What we heard report

Stage 1 public consultation: Draft Lachlan Valley Floodplain Management Plan

September 2026

Figure 2: Refinements made to the proposed Lachlan Valley Floodplain Boundary near Lake Cowal

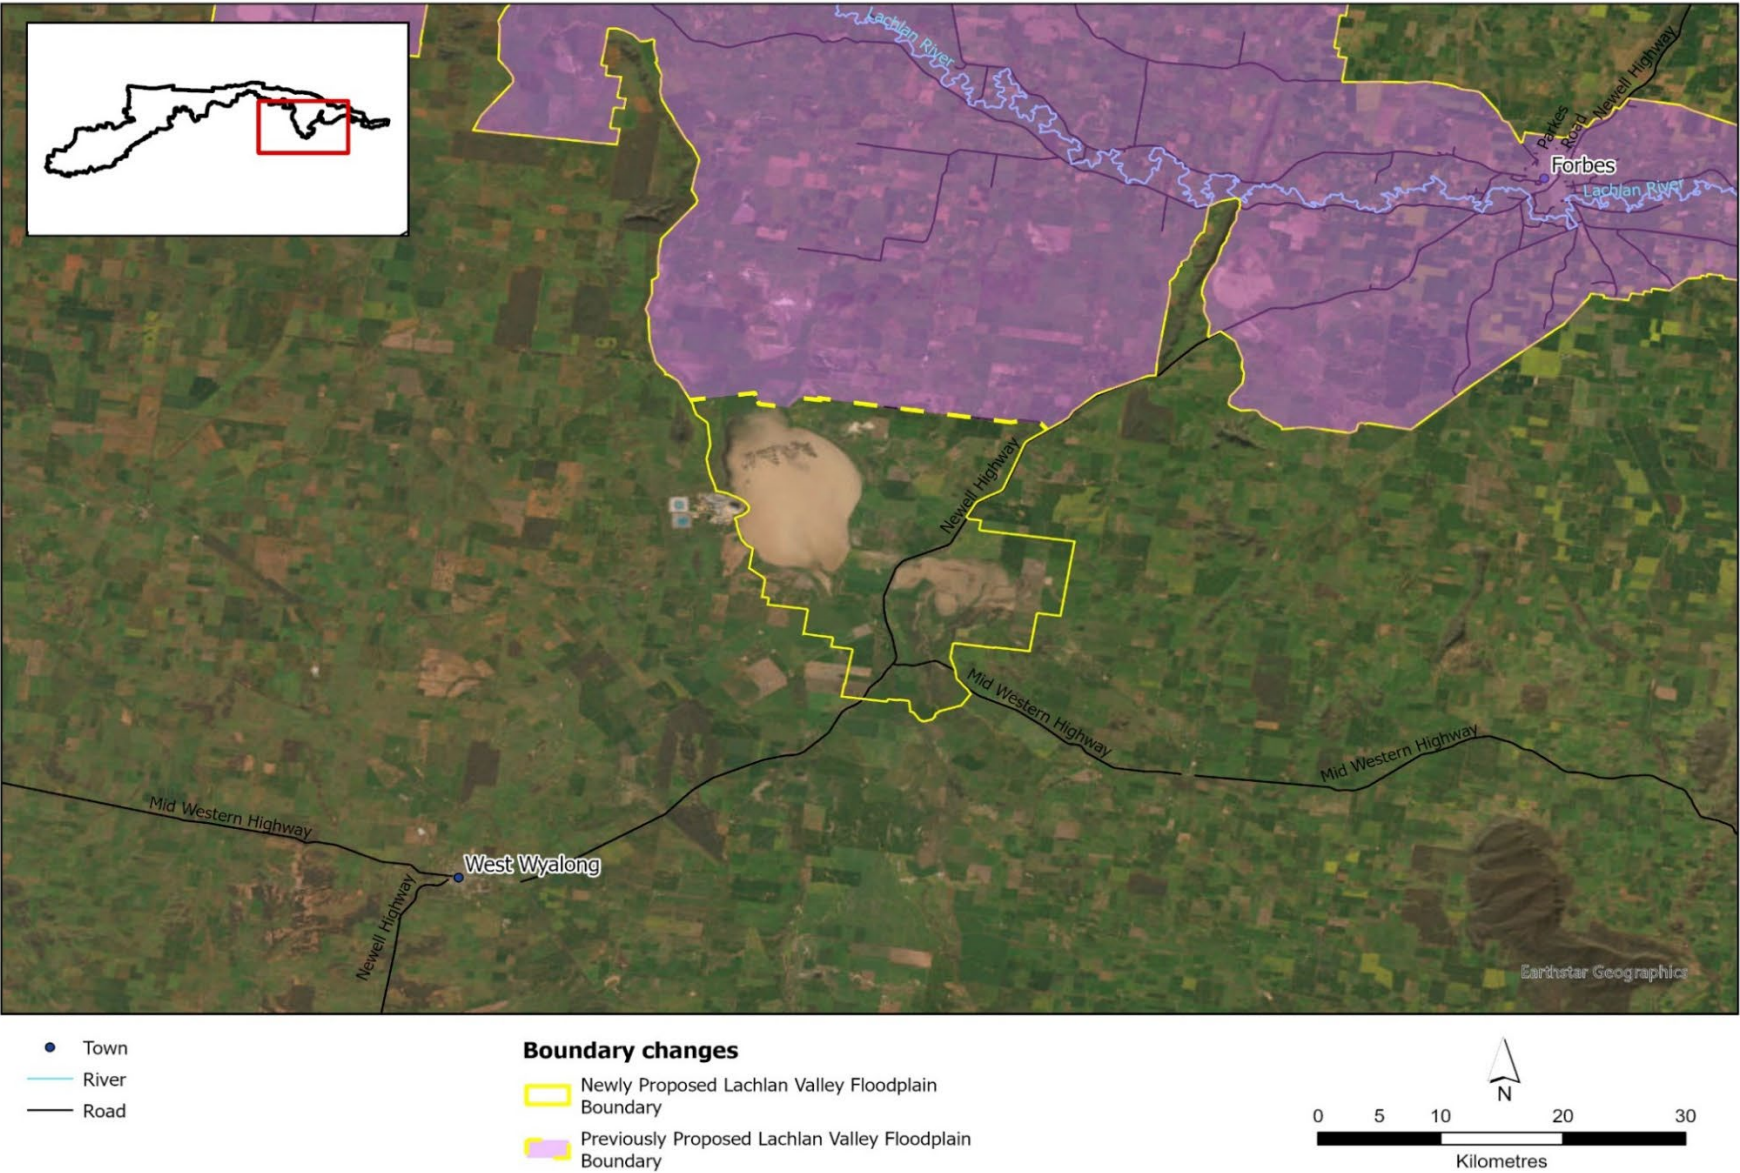
Why is Lake Cowal outside the floodplain boundary when Nerang Cowal is within it?	In response to feedback received, the proposed floodplain boundary has been refined to include Lake Cowal, as shown in Figure 2 in Appendix 2.
We consider that a whole-of-valley Floodplain Management Plan should account for the full Lachlan catchment, including upstream areas such as Cowra, where we believe flood works influence downstream flood behaviour.	The upstream areas of the Lachlan catchment are managed under the Cowra and Gooloogong Floodplain Risk Management Plan. This is the more appropriate instrument for managing local urban flood risk in these areas. Excluding these areas from the proposed floodplain boundary avoids regulatory duplication and confusion.

Figure 2 shows the change made to the proposed Lachlan Valley Floodplain boundary in response to stakeholder feedback. The change extends the proposed floodplain boundary to include Lake Cowal and Bland Creek.

Figures 3 to 14 provide an overview of refinements to the proposed floodway network in response to stakeholder feedback and updates to the hydraulic model to better reflect the historical FMPs.

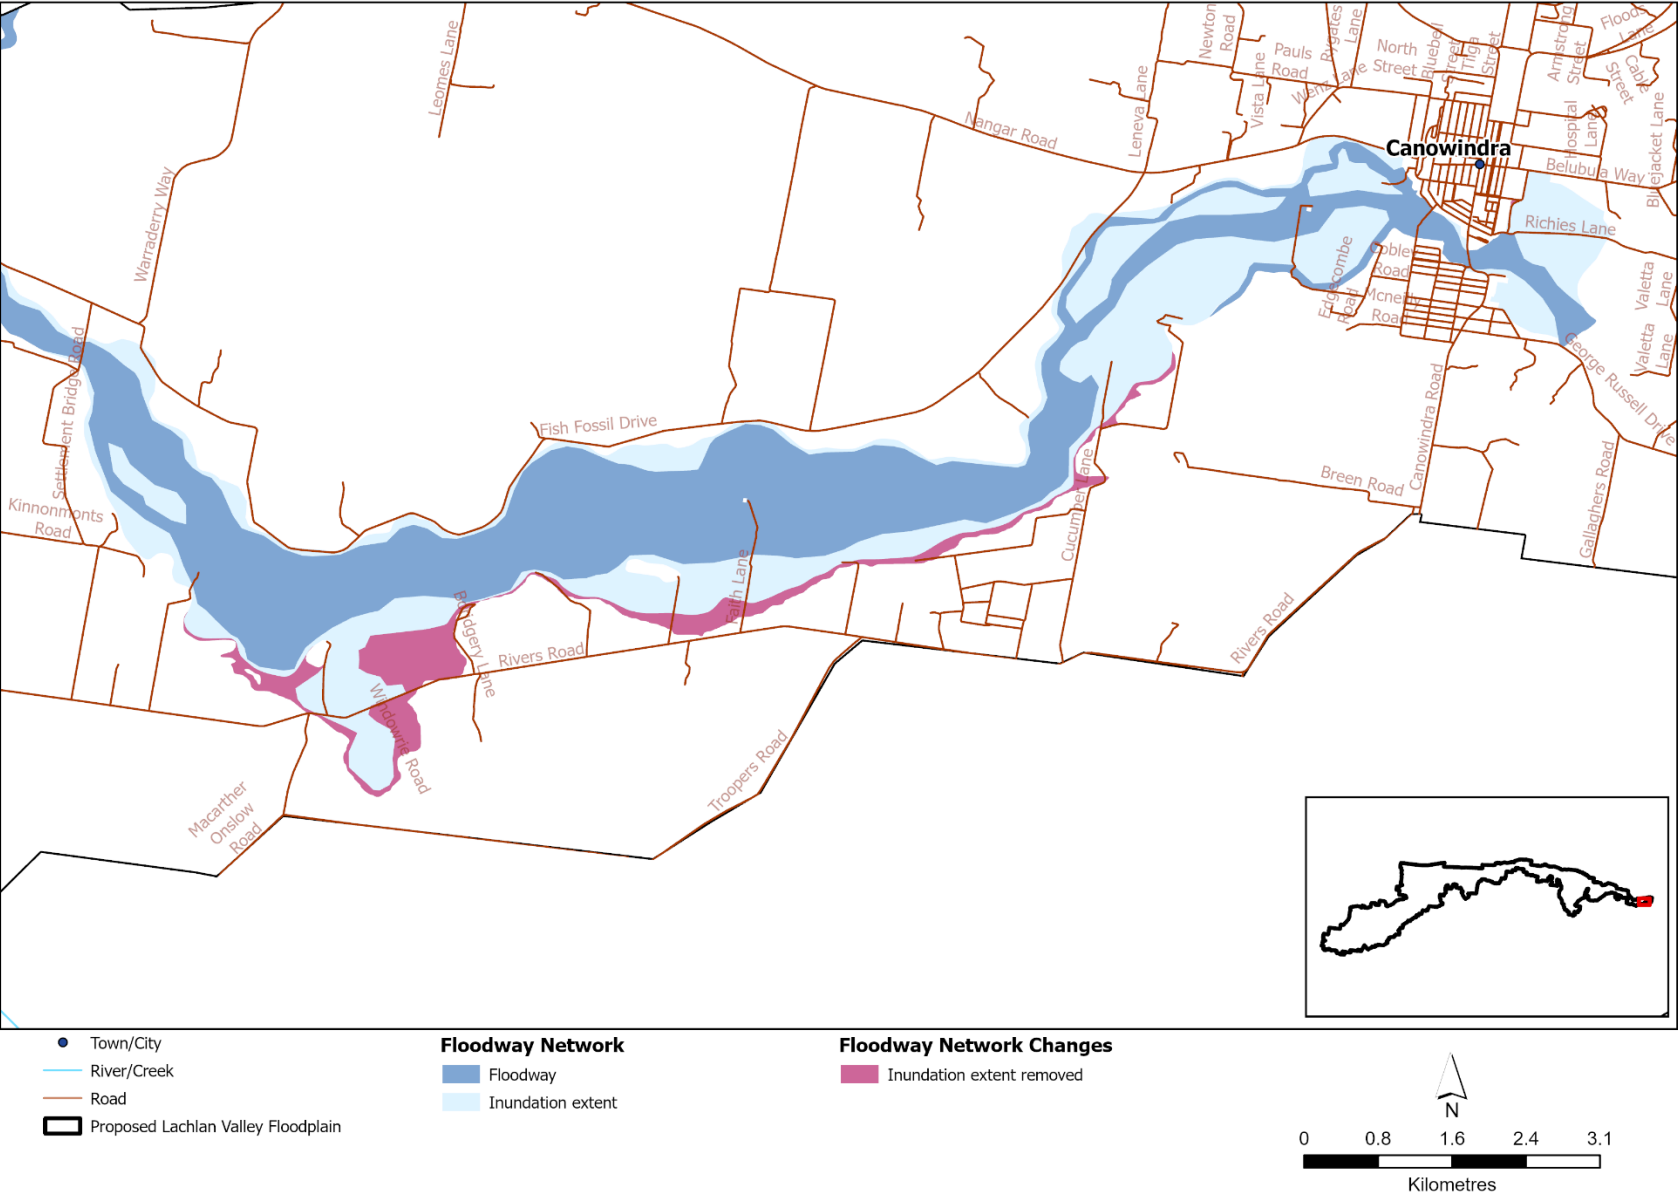
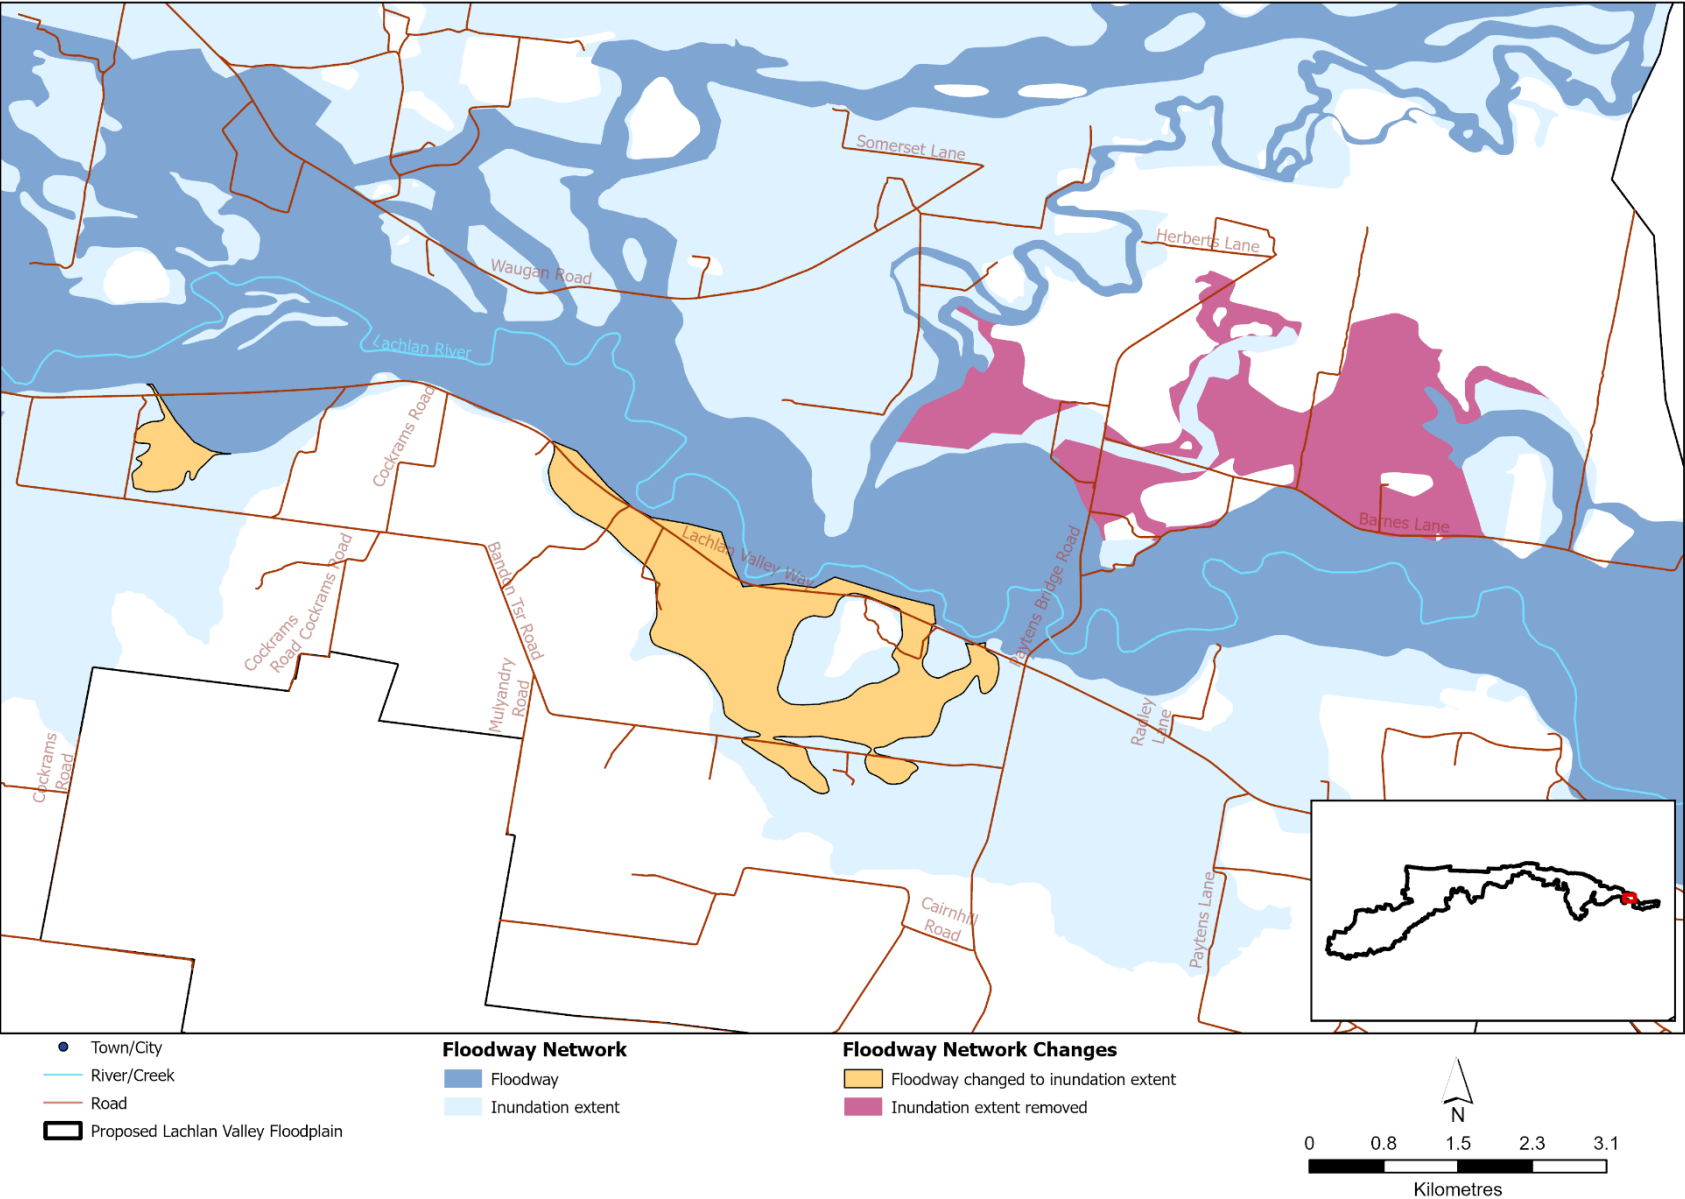
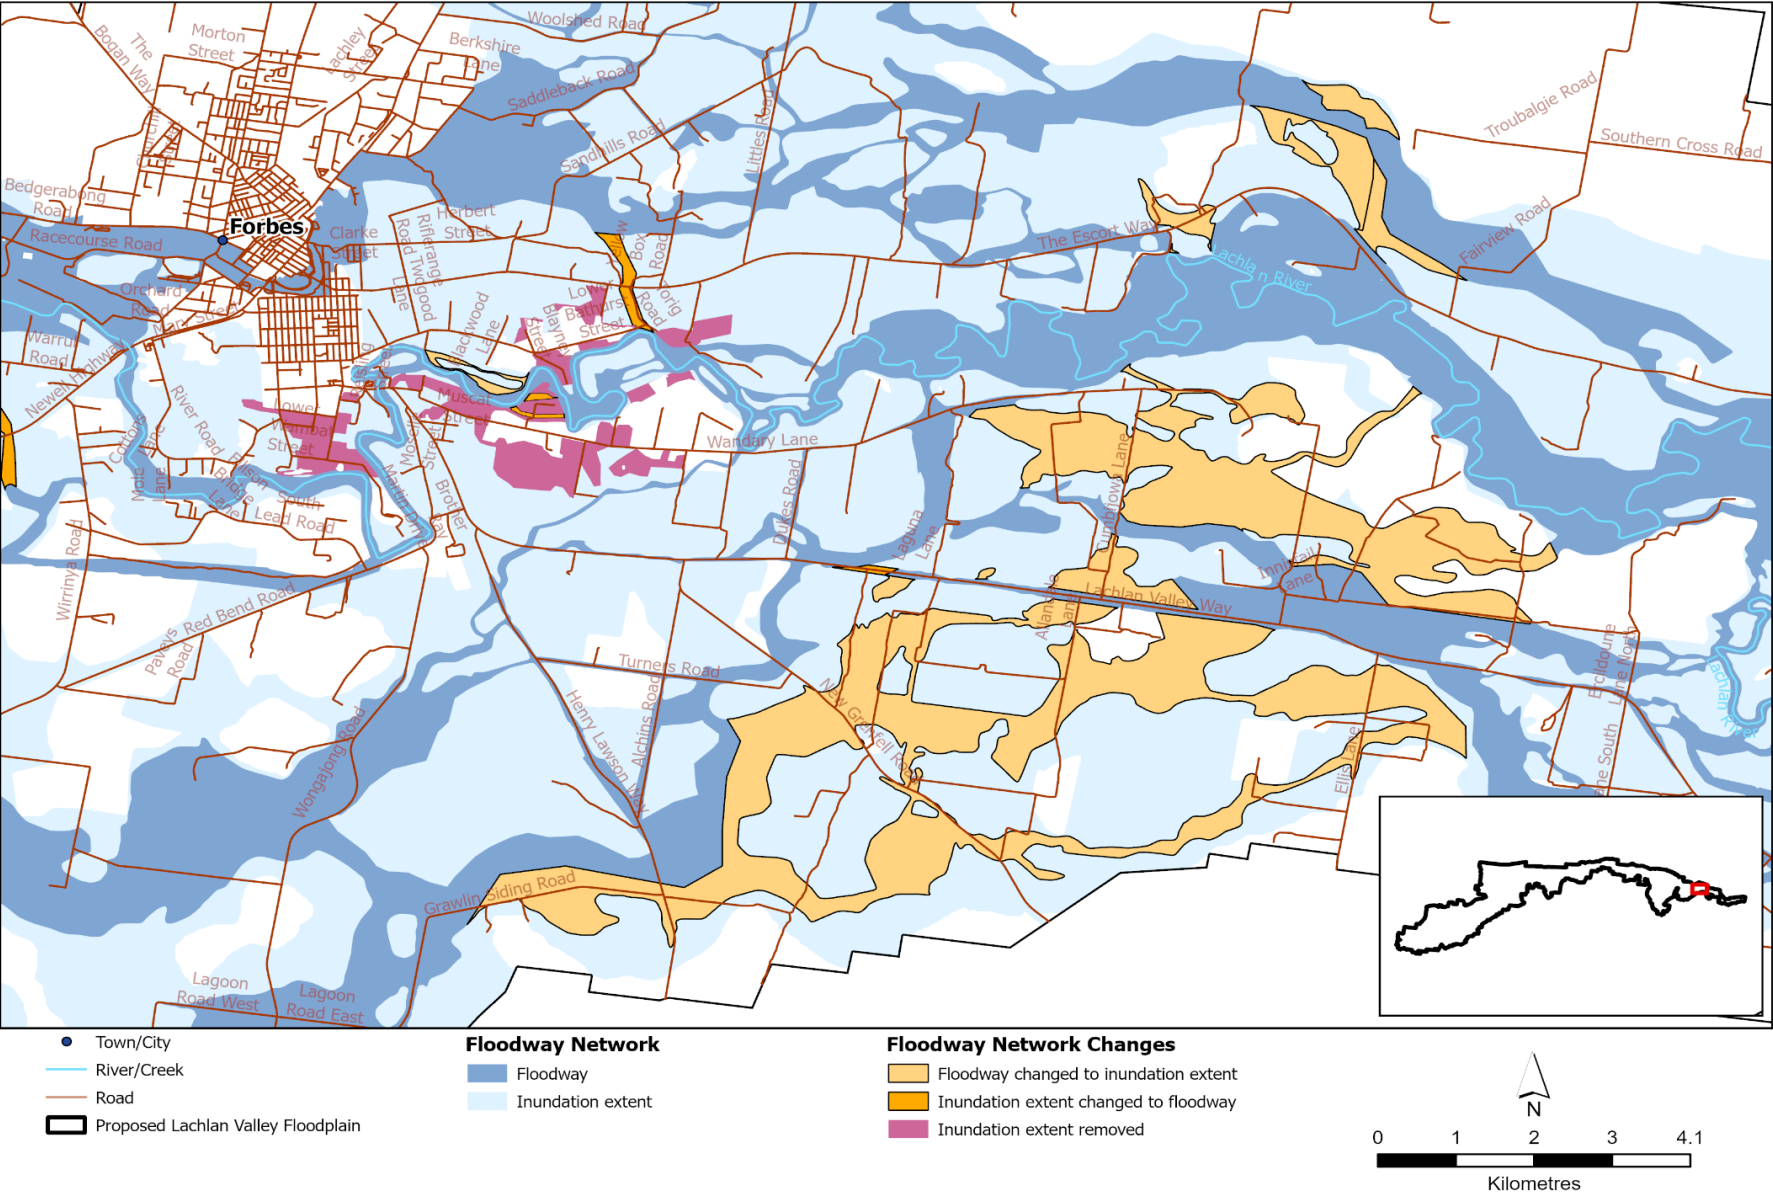
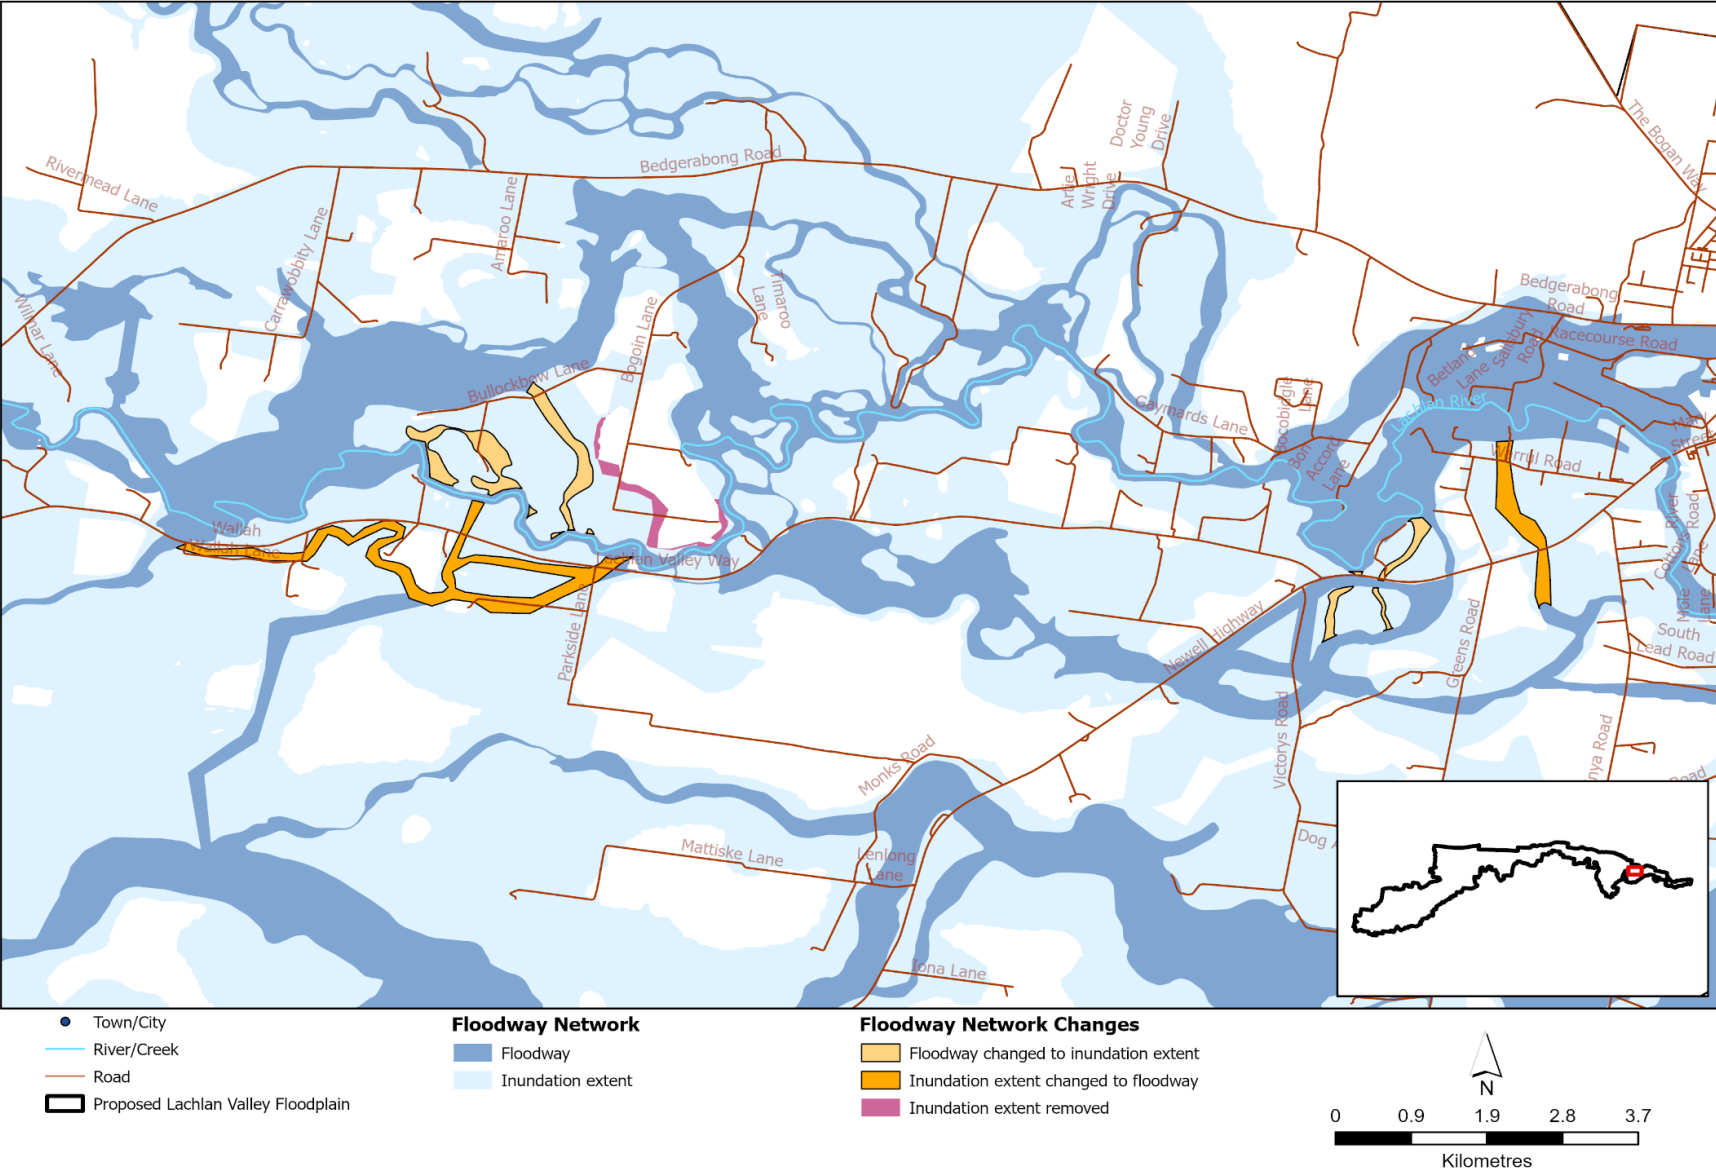
Feedback	Departmental response
Missing floodways from previous plans. There are several foodways that are completely missing from the draft plan, for example Greens Creek downstream of Forbes, and upstream from Jemalong gap.	In response to feedback, we updated the hydraulic model to better reflect the historical FMPs. Spatial refinements that resulted from this model update are shown in Figures 3 to 14 in Appendix 2.
The proposed floodway boundary near Lake Cowal is significantly narrower than the existing floodway. In our view, this may reduce the floodway's ability to convey and redistribute flood flows, increasing the risk of flood impacts and infrastructure failure.	See response above.
Local observations and on-ground validation should be used to validate, refine, and finalise modelling outputs.	Agree. Modelling outputs are validated using satellite imagery, surveying results, LiDAR and topographical information. Further, site-specific information and local flood knowledge provided through consultation, including information relating to flood behaviour, historical inundation and floodplain infrastructure in the identified areas, is considered during ongoing refinement of the proposed floodplain boundary and associated mapping.

We should follow the same guidelines that were used to approve flood works in past floodplain management plans to avoid operational changes and cost blowouts to landholders and communities.	See response above. In response to feedback, we updated the hydraulic model to better reflect the historical FMPs. The spatial refinements that resulted from this model update are shown in Figures 3 to 14 in Appendix 2.
